**Subject: Comments to Proposed Rule and Part 61 Guidance, Low-Level
Radioactive Waste Disposal, 80 FR 16082 and 80 FR 15930**

COMMENTS ON THE PROPOSED REVISIONS TO 10 CFR PART 61

COMMENTS ON NUREG-2175, GUIDANCE FOR CONDUCTING TECHNICAL ANALYSES FOR 10 CFR PART 61

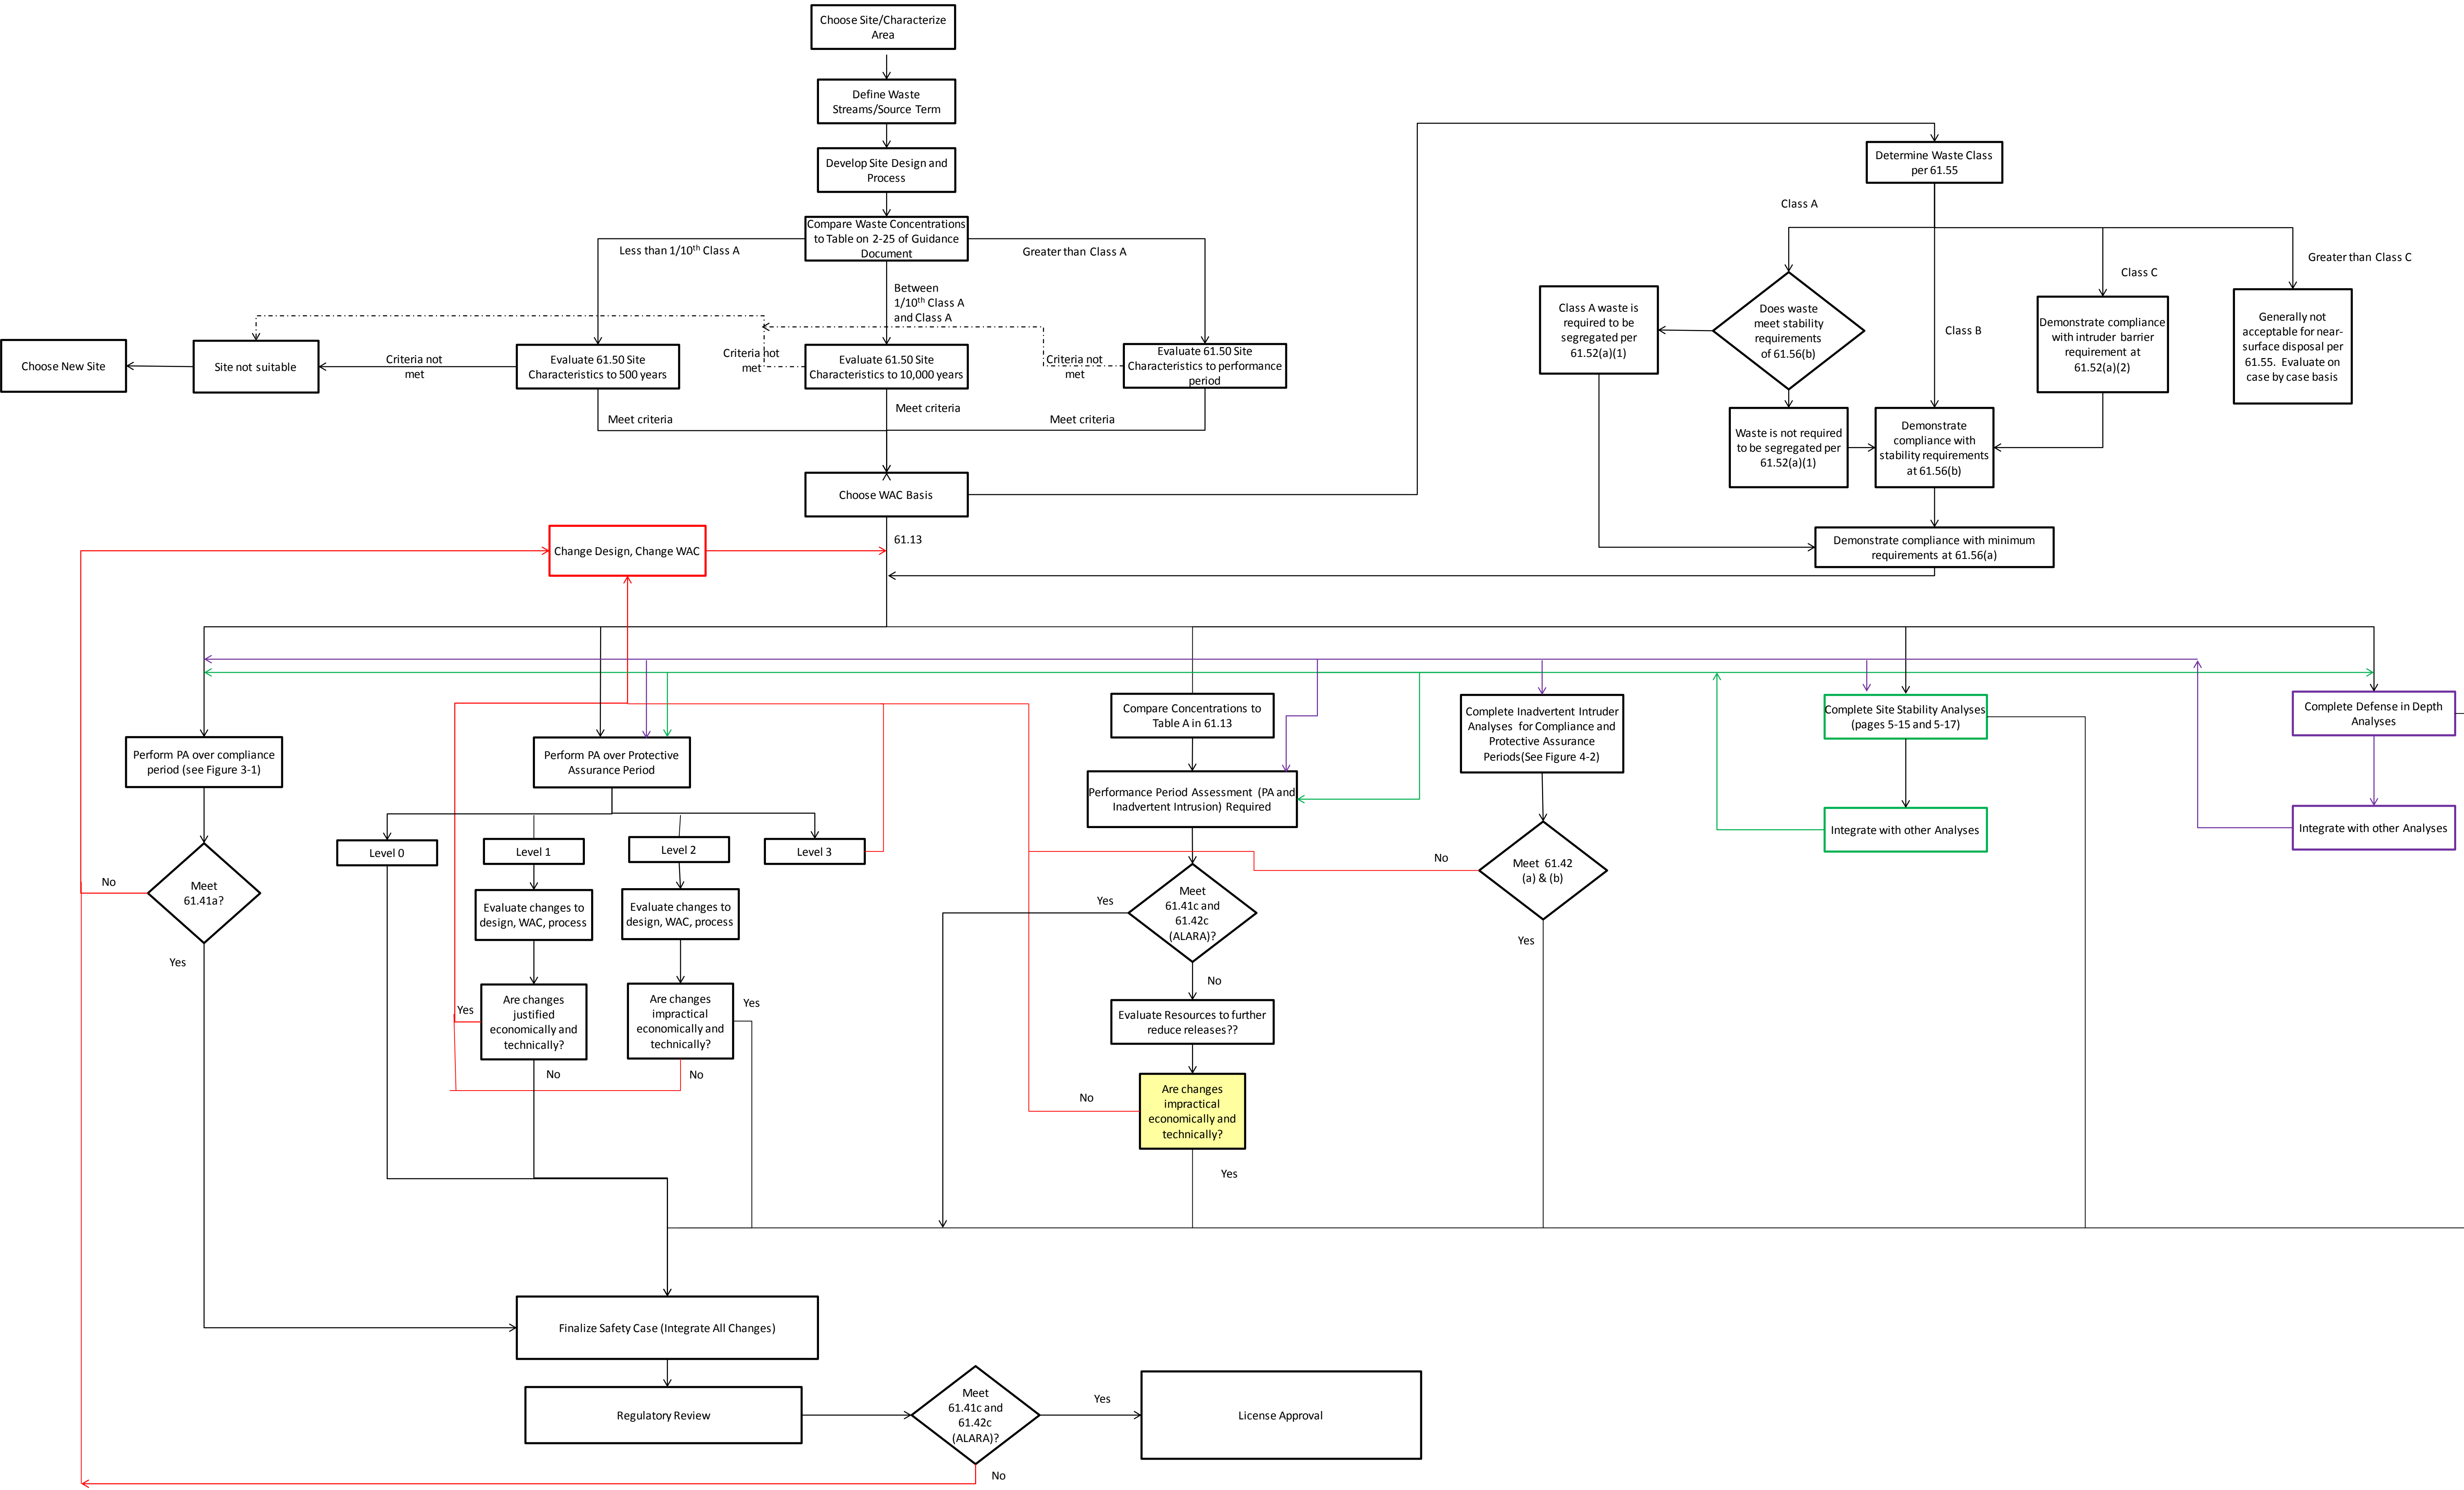
We attempted to create a flowchart to fit the pieces of the proposed rule together (see Figure 1). This flowchart clearly illustrates the cumbersome nature of the process. We recommend several changes that should streamline the process, including using a two-tier system. These are discussed in further detail in the following sections.

Recommendation – We propose that the NRC include a flowchart of the process so that an applicant or licensee can understand the components, requirements, key decision points, and how they fit together.
